## Synopsis Critique of Letter to Amber Rudd MP from S Batchelor

**Enquiry Number:** DCQ/14/00357

**Subject:** Replacement of single storey holiday let with a two storey holiday let

**Location:** Rocklands Private Caravan Park, Rocklands Lane, Hastings, TN35 5DY

## Dimensions Zero cottage

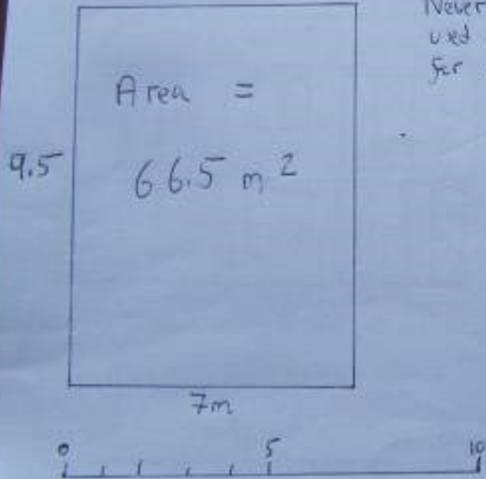
Built on footprint of old bungalow.

Never built but used as case for new building

## New Building

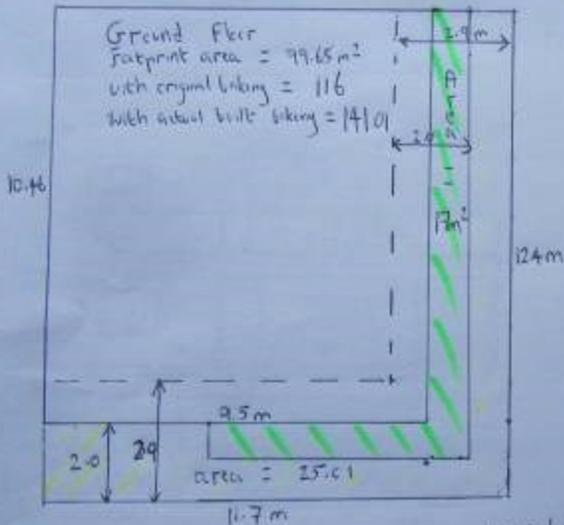
--- line of building on smaller footprint in original plans  
a) built
